Our Ref: 80017026-L03:BCP/bcp  
Contact: Dr Brett C. Phillips

**FLOOD IMPACT ASSESSMENT OF WESTFIELD WARRINGAH MALL PROJECT –  
STAGE 2 REDEVELOPMENT**

Figure A.1D  
Reference Locations for Flood Levels

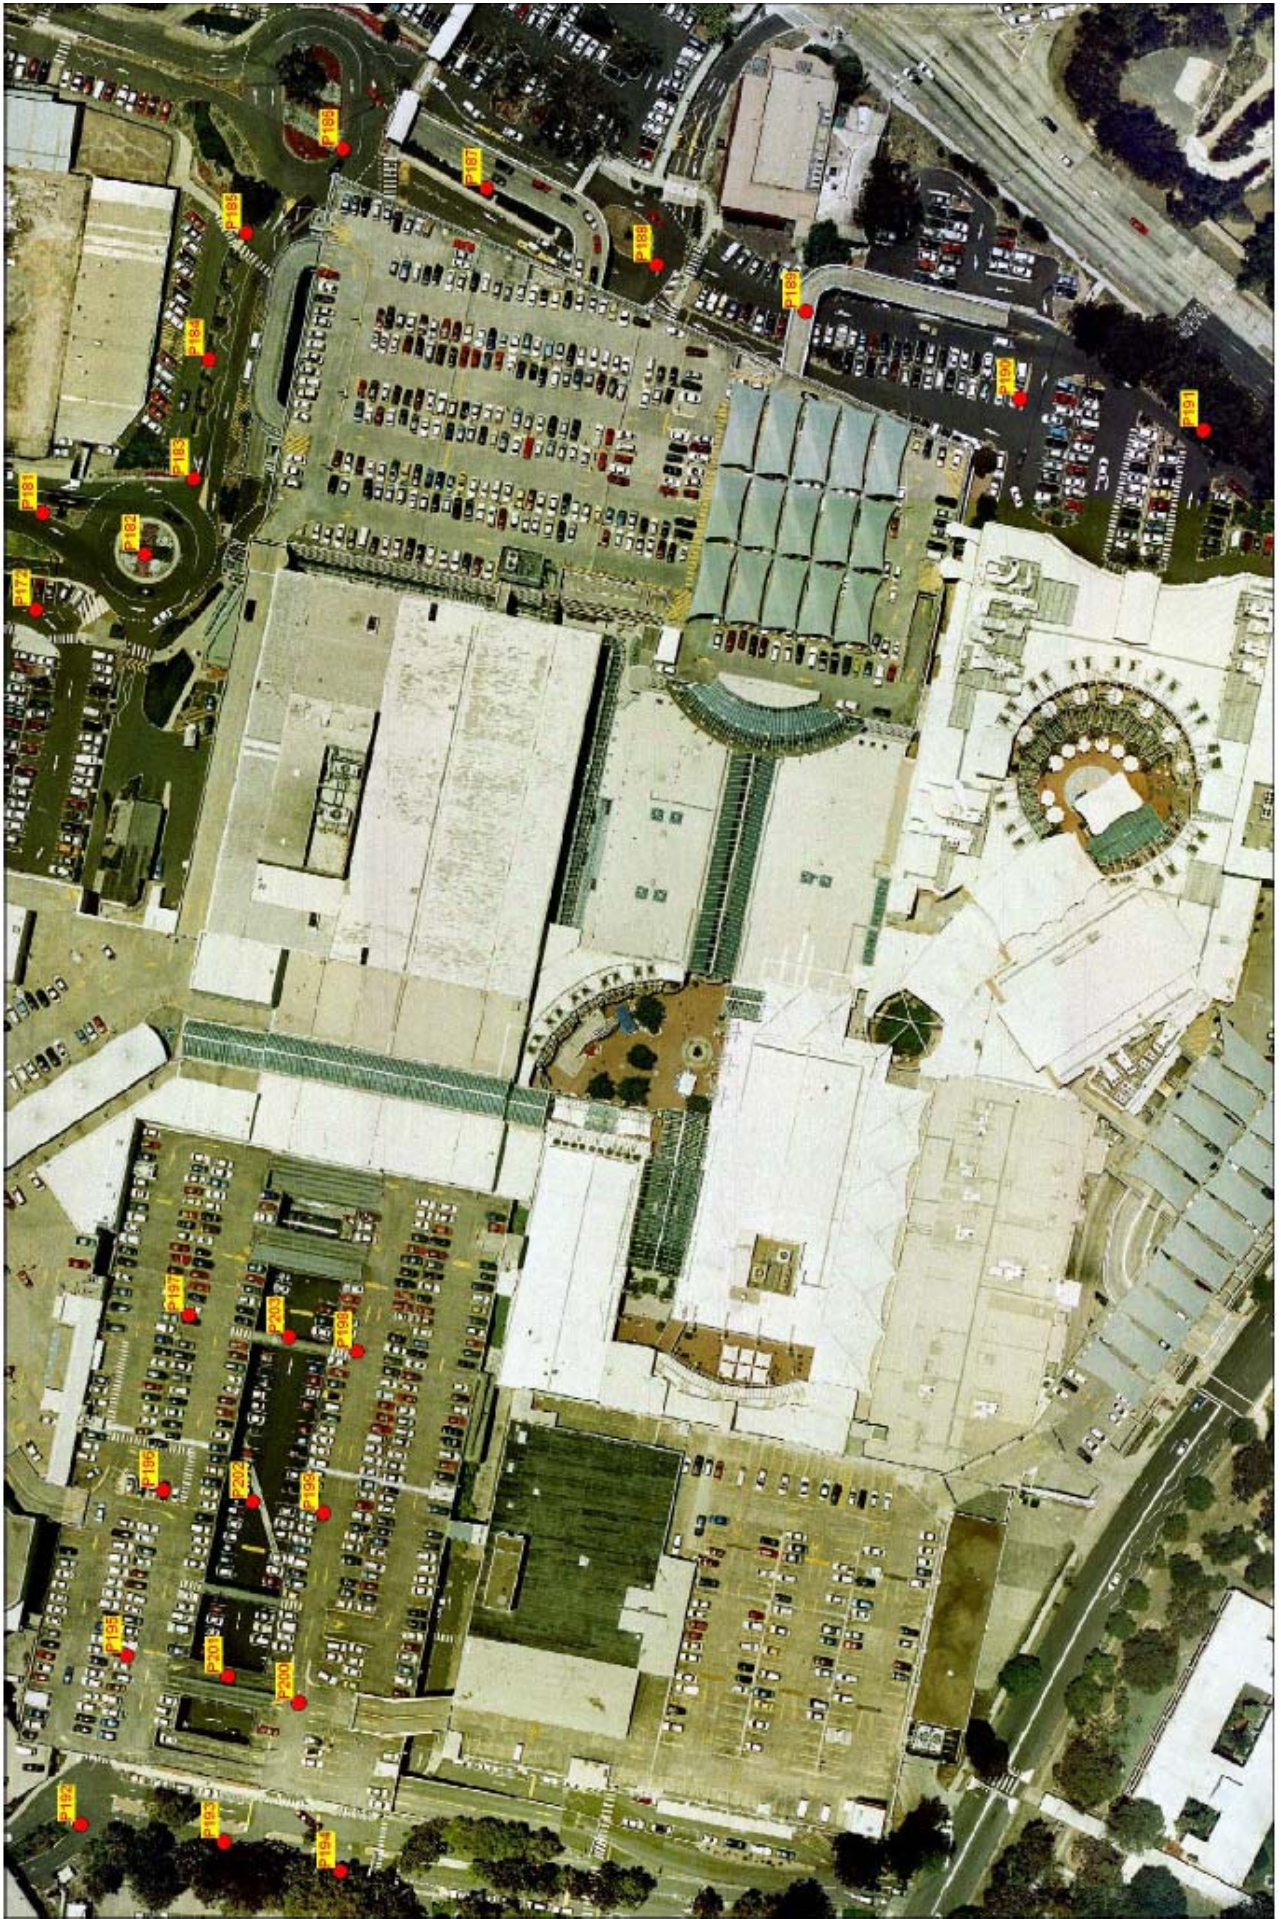
5. *Table A.5 in Attachment B and Attachment A - the Table provides comparison of the baseline 100 yr flood scenarios and levels at many locations upstream of the Mall.*

1. *The applicant should provide a plan similar to Attachment A which shows the location of all the Survey Points listed in Table A.5. This will allow review of all the results in and around the Harrison property so we can gain a better understanding of the flood behaviour in the area.*

The location of all reference locations are given in the attached Figures which identify the locations of the original reference points (which have remained unchanged for 10+ years) and the locations of series, 200, 300, 400 and 500 reference points which were subsequently added in local areas of interest in 2013.

The location of all reference locations are given in the attached Figures which identify the locations of the original reference points (which have remained unchanged for 10+ years) and the locations of series, 200, 300, 400 and 500 reference points which were subsequently added in local areas of interest in 2013. It is noted that the reference points in and around the Harrison property are also included in the final Flood Management Plan for Lot 2 DP 600059 No. 75 Old Pittwater Road, Brookvale dated 16 August 2016.
